INSERVICE TESTING PROGRAM
SECOND TEN-YEAR INTERVAL
SAN ONOFRE UNITS 2 AND 3

PUMP RELIEF REQUEST No. 13

PUMP RELIEF REQUEST No. 14

QC II	UNIT 2
								LOCATION:	SAN ONOFRE NUCLEAR GENERATING STATION
								SALTWATER COOLING PUMP TAG NO. 2P-307 IST CURVES	
								 Southern California Edison	
E	MADE	CKD	RE	IRE	GS	DM	OTHER	DWG	41067 Sh.4 REV 1

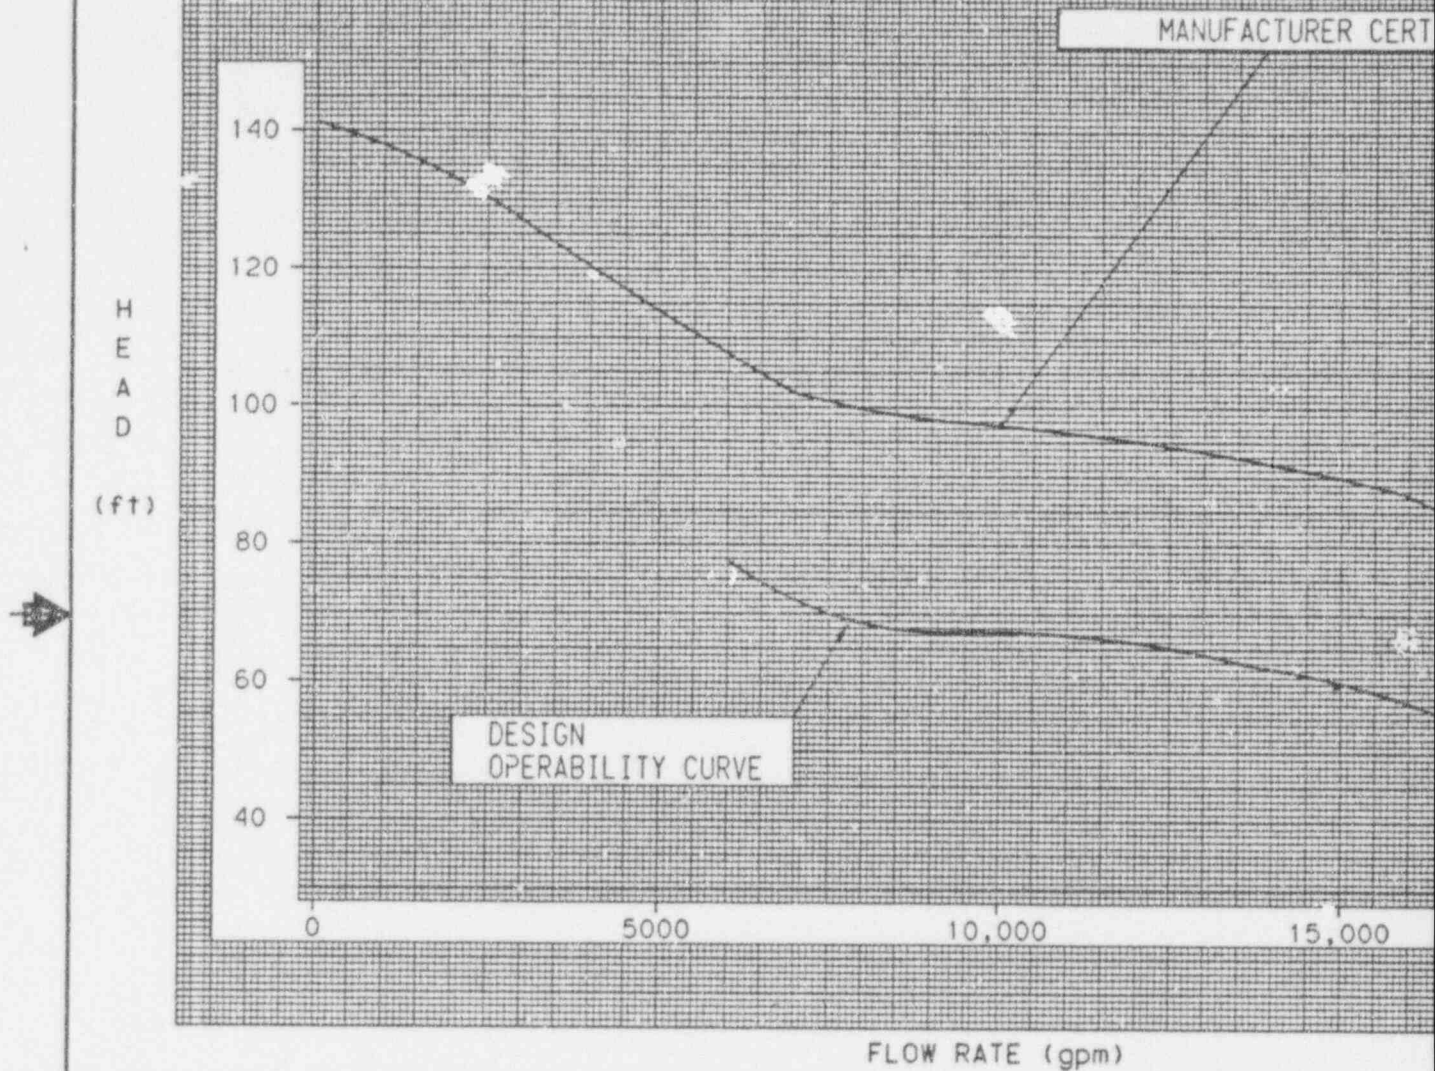
The SWC pumps operate well above the flow and pressure differential assumed in the safety analysis. The margin from the current reference DPs to the DP required by the safety analysis limits is shown in the following table. The design operability curve for the pump with the least margin (2P307) is also attached. It can be seen that any pump degraded by the 7% necessary to place it into the required action range per OM-6 (Column 3) would still be well above the safety analysis limits (Column 4).

This would still maintain a minimum of 10% margin to the safety limits in the most conservative case (2P307). Vibration limits would remain as required in OM-6 Table 3a.
